Work Order ID 153368

Item ID: DSI 9410-011 Accept *N900040100* Setup Start *NS1*
 Revision ID: Stop *NS2*
 Item Name: Amends Installation of D350-591-311/-312 Steps
 Start Date: 11/18/2016 Start Qty: 2.00 *2* Cust Item ID:
 Required Date: 11/22/2016 Req'd Qty: 2.00 *2* Customer:
 Reference:

DART SERVICE INSTRUCTION

TO AMEND DRAWING D350-591 REV. F

FIGURE 1 - CLAMP/CUSHION INSTALLATION

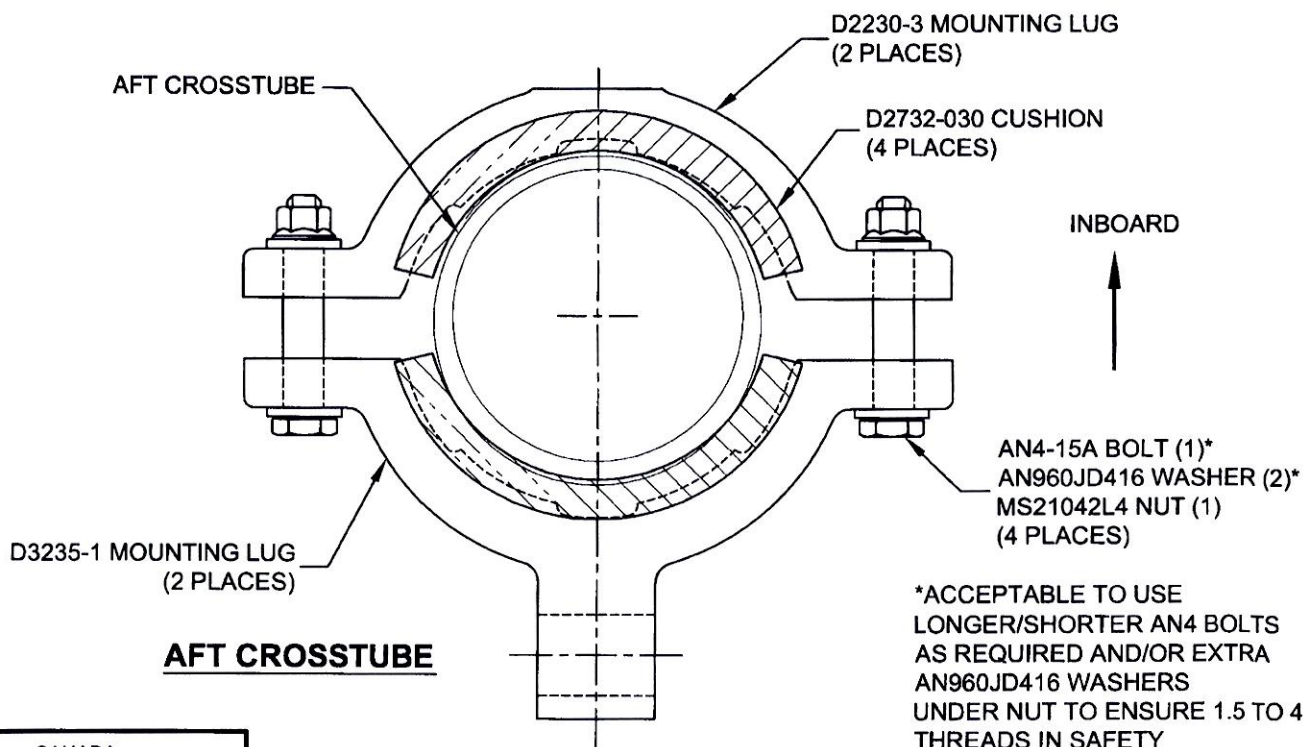
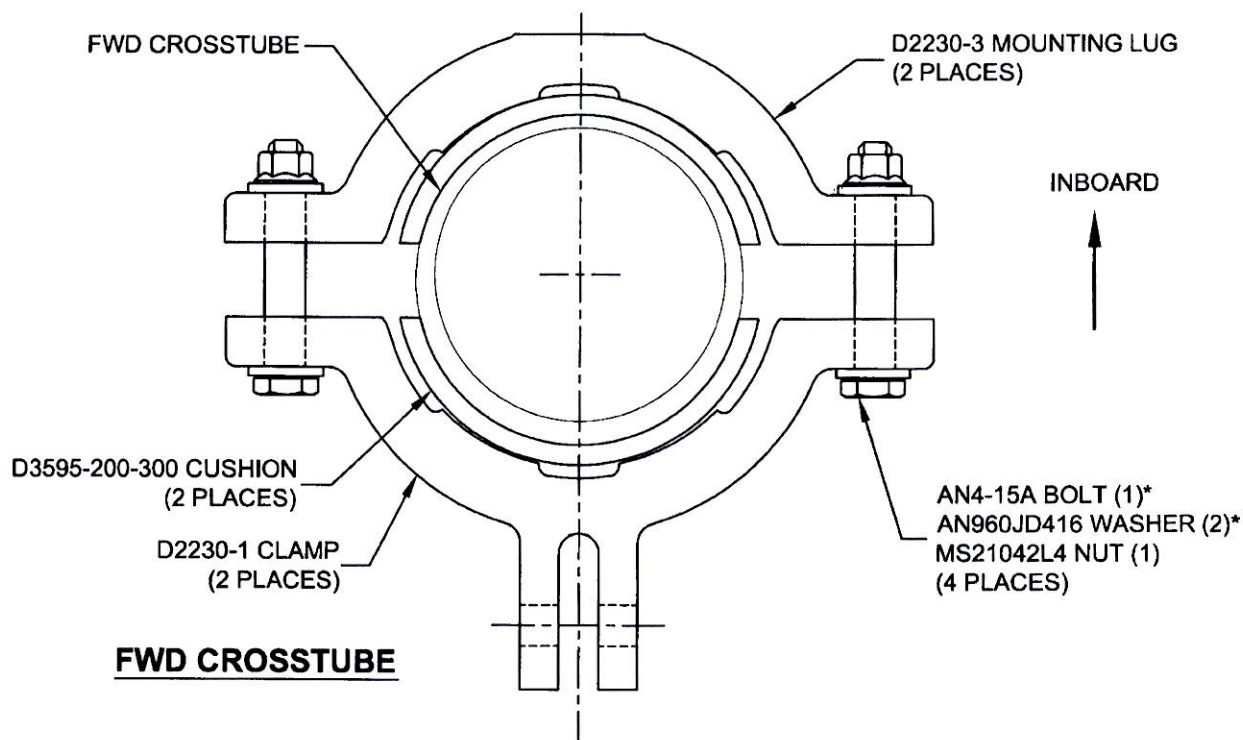
TO IMPROVE THE FIT OF THE D350-591-311/-312 STEPS, IT IS ACCEPTABLE TO INSTALL THE DSI 9410-011 KIT. INSTALL THE D2732-030 CUSHION (AFT CROSSTUBE) AND D3595-200-300 CUSHION (FWD CROSSTUBE) AS SHOWN IN FIGURE 1 IN PLACE OF THE D2856-400-720 ABRASION STRIP CALLED OUT ON DRAWING D350-591 REV. F.

FOR CUSTOMERS WHO HAVE PREVIOUSLY INSTALLED D2856-400-720 ABRASION STRIPS
REMOVE THE ABRASION STRIPS IN ACCORDANCE WITH ICA-D350-591.
PRIOR TO INSTALLING THE DSI 9410-011 KIT.
